ENVIRONMENTAL PROTECTION AGENCY**40 CFR PART 52**

Final Response to Petition From New Jersey Regarding SO₂ Emissions From the Portland Generating Station**AGENCY:** Environmental Protection Agency (EPA).**ACTION:** Final rule.

SUMMARY: The EPA is making a finding that the coal-fired Portland Generating Station (Portland), owned and operated by GenOn REMA LLC (GenOn), in Upper Mount Bethel Township, Northampton County, Pennsylvania, is emitting air pollutants in violation of the interstate transport provisions of the Clean Air Act (CAA or Act). Specifically, the EPA finds that emissions of sulfur dioxide (SO₂) from Portland significantly contribute to nonattainment and interfere with maintenance of the 1-hour SO₂ national ambient air quality standard (NAAQS) in New Jersey. This finding is made in response to a petition submitted by the State of New Jersey Department of Environmental Protection (NJDEP) on September 17, 2010. In this action, the EPA is establishing emission limitations and compliance schedules to ensure that Portland will eliminate its significant contribution to nonattainment and interference with maintenance of the 1-hour SO₂ NAAQS in New Jersey. Compliance with t

Figure VI.C-1. Comparison of 2010 Emissions from Portland Units 1 and 2 with Allowable Emissions and Different Levels of Reduction from Allowable Emissions.

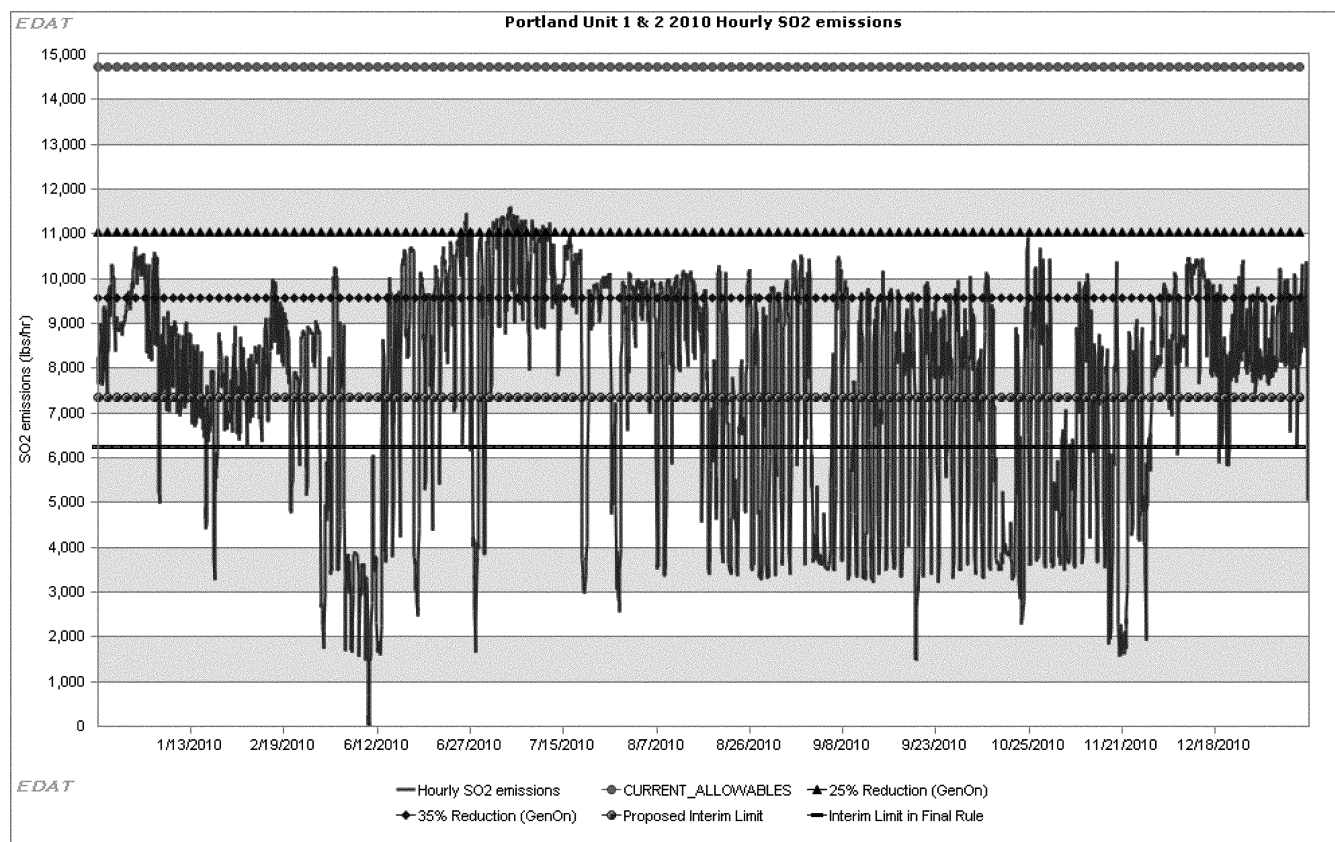
Comment: Based on the results of the test burn report, GenOn concluded that (1) Sustained unit operations using a blend of Northern and Central Appalachia coals sufficient to achieve a 25 percent reduction in allowable SO₂ emissions is achievable with a modest investment and an implementation schedule of 6 months, and (2) sustained unit operations using a blend of Northern and Central Appalachia coals to achieve a 35 percent reduction in allowable SO₂ emissions should be achievable with additional investments and an implementation schedule of 8 to 12 months after GenOn has established an operational record and completed equipment performance evaluations at the 25 percent reduction blend level, and any necessary permits are acquired.

Response: The EPA evaluated the suggested interim reductions in the GenOn test burn report. The EPA concluded that based upon this evaluation, these targets are significant underestimates of the readily available interim emissions reductions, represent very minimal reductions from current operations, and are inconsistent with the results of the test burn.

Figure VI.C-1 shows the hourly SO₂ emissions for all of 2010 at Portland, shown as the sum of emissions from units 1 and 2. For the EPA (and GenOn's) air quality analysis, the assumed allowable emissions rates for units 1 and 2 were 5,820 lb/hr and 8,900 lb/hr, respectively, resulting in a total allowable rate of 14,720 lb/hour. A 25

percent reduction from this amount, that is a 25 percent reduction from current allowable, thus becomes 11,040 lb/hr. As shown in Figure VI.C-1, during 2010, Portland's hourly emissions exceeded 75 percent of

allowable emissions only rarely. Accordingly, a 25 percent reduction in allowable emissions effectively represents status quo operations. A 35 percent reduction in allowable emissions, or 9,568 lb/hr, would require

at most a roughly 15 percent reduction in current emissions. EPA continues to believe that the facility can make much more significant reductions in line with the final interim limits within a year.
